RE: 915 Silver Ave. SW
Grading and Drainage Plan
Engineer's Stamp Date: 07/25/19
Hydrology File: K14D118

Re: Hydrology File #K14D118, 915 Silver Ave. SW

I have attached a revised grading & drainage plan that addresses your comments of July 19, 2019. The comments have been addressed as follows:

Site Section Swale

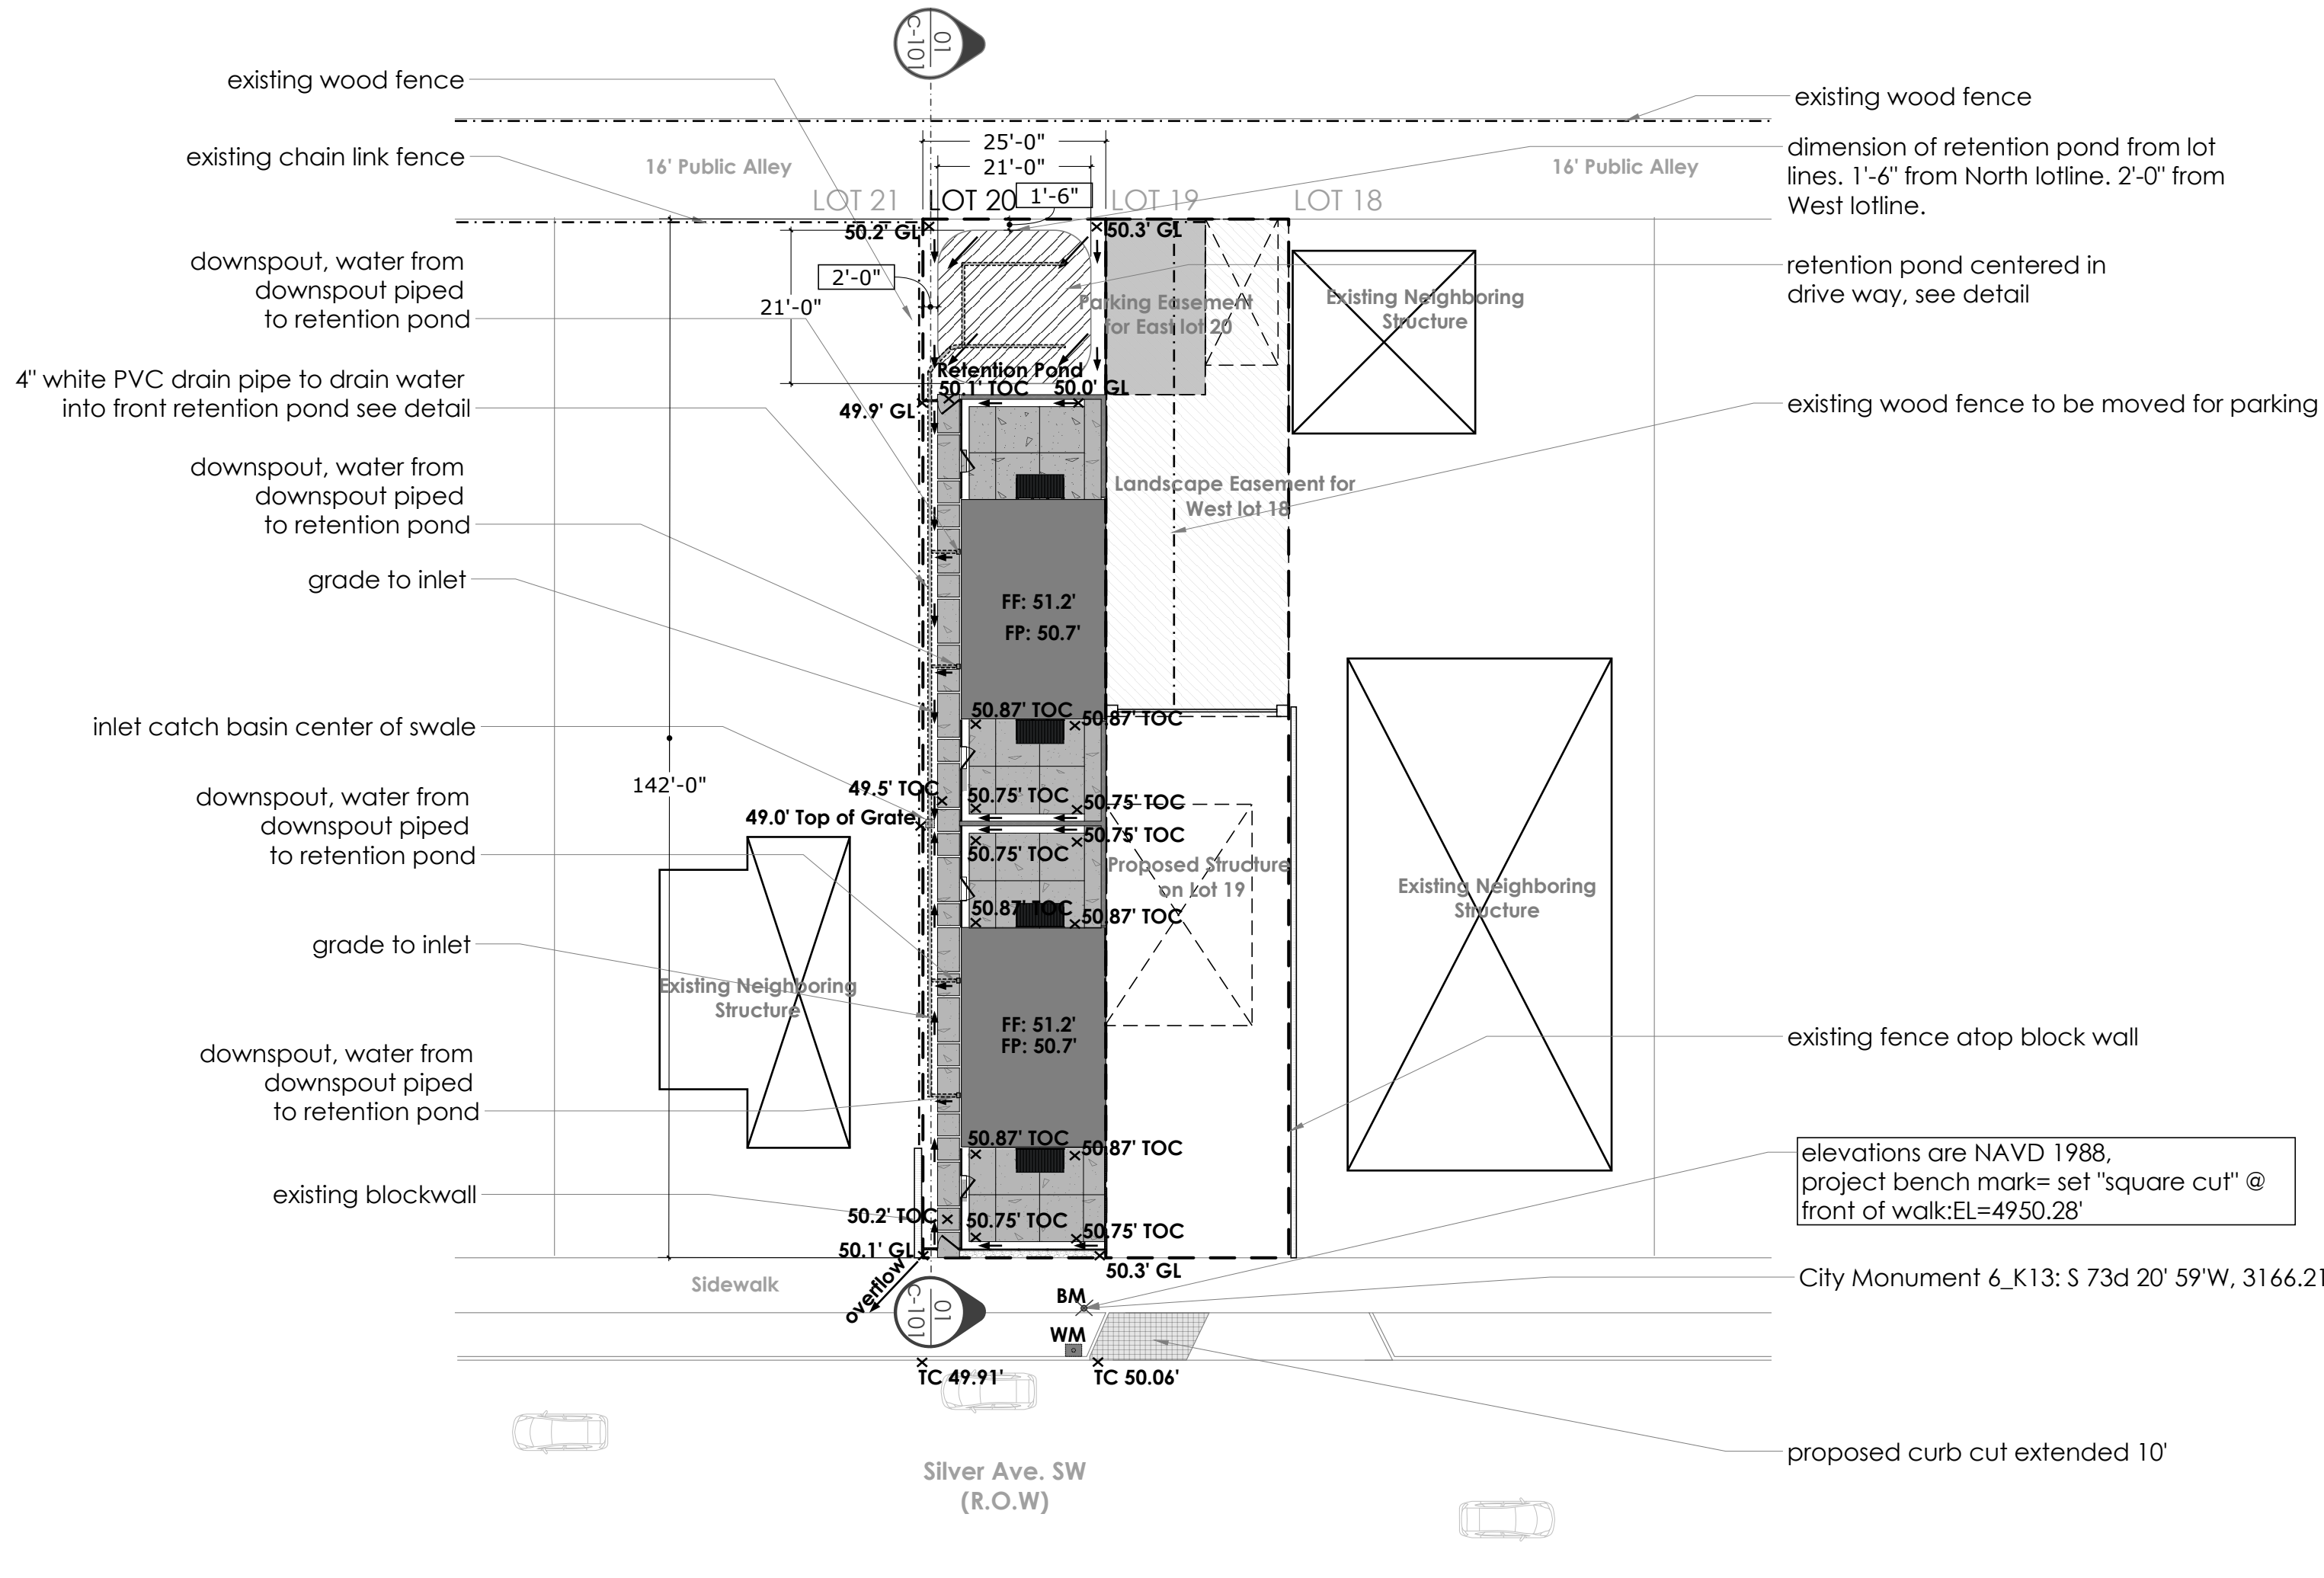
15. The site section does not provide any relevant information and can be removed. *The section now shows piping inverts and slopes for the proposed swale and area drain system as requested in 9 above.*

Retention Detail

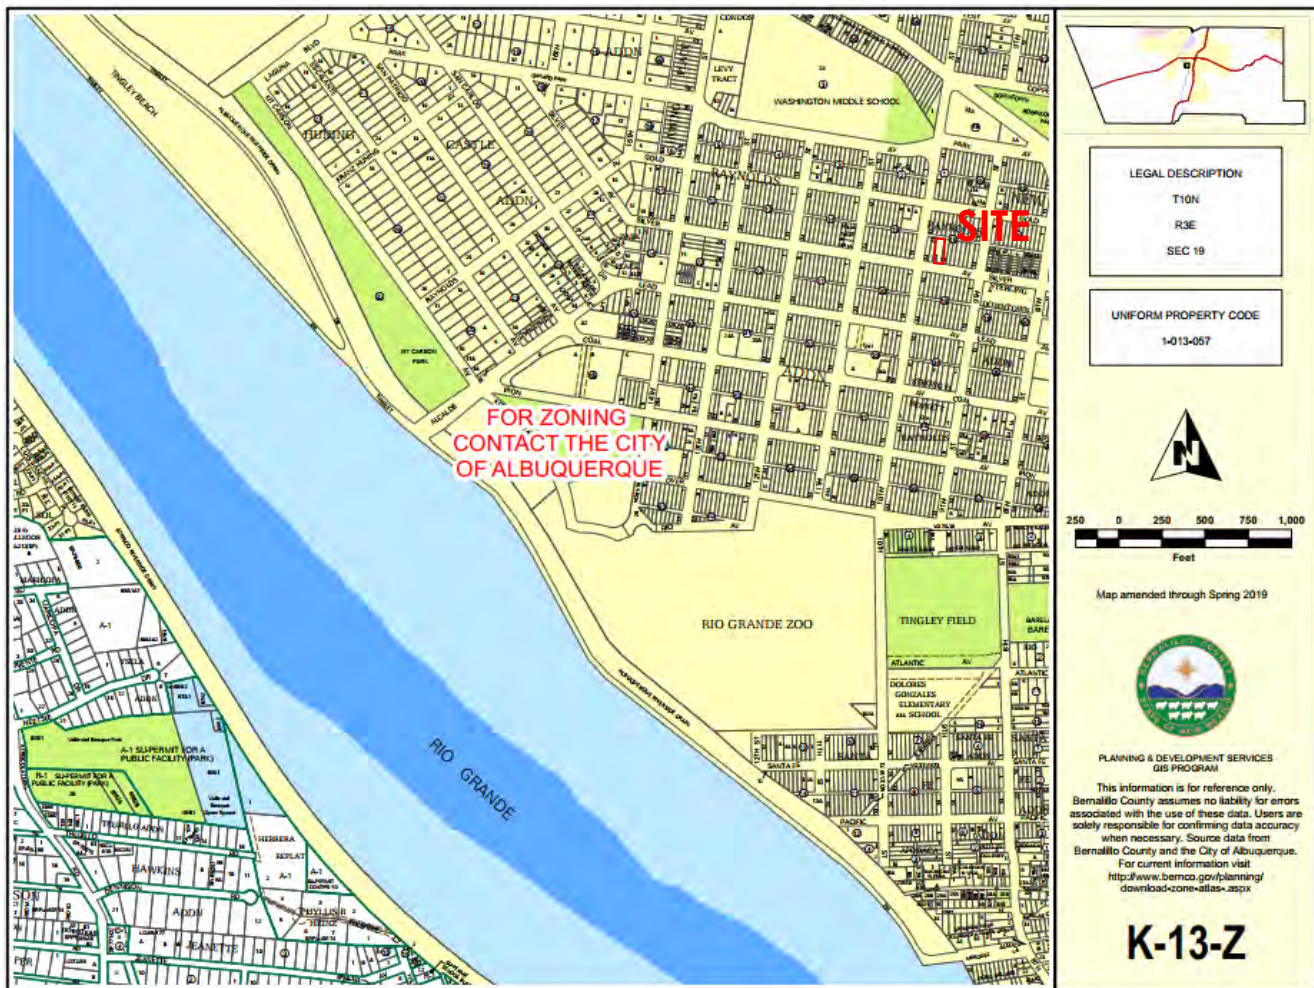
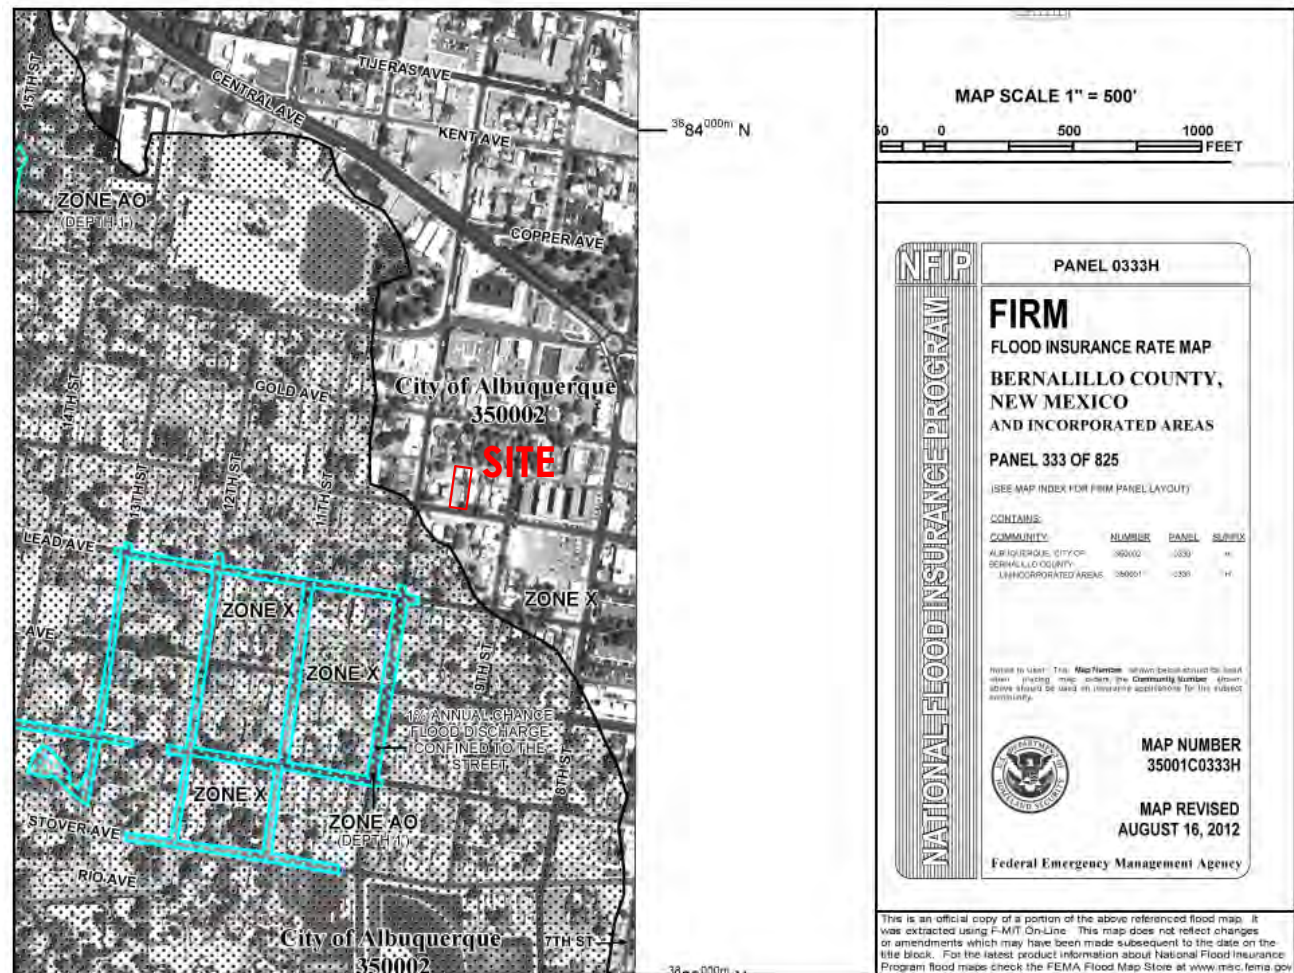
12. Please show how the overflow of 0.1 cfs is leaving the site from the retention pond. *The overflow location is shown on the plan.*
13. Please clarify the retention detail dimensions. Are these in inches or feet? Also please use aggregate instead of clean rounded cobble. *Dimensions have been provided. The clean rounded cobble is required to achieve the 30% porosity for the underground stormwater storage area.*

14. In the provided retention pond volume calculations, which dimensions are to be used in this project? There are five shown. *The developer has chosen the 21'x21'x4.4 configuration. This is shown on the plan.*
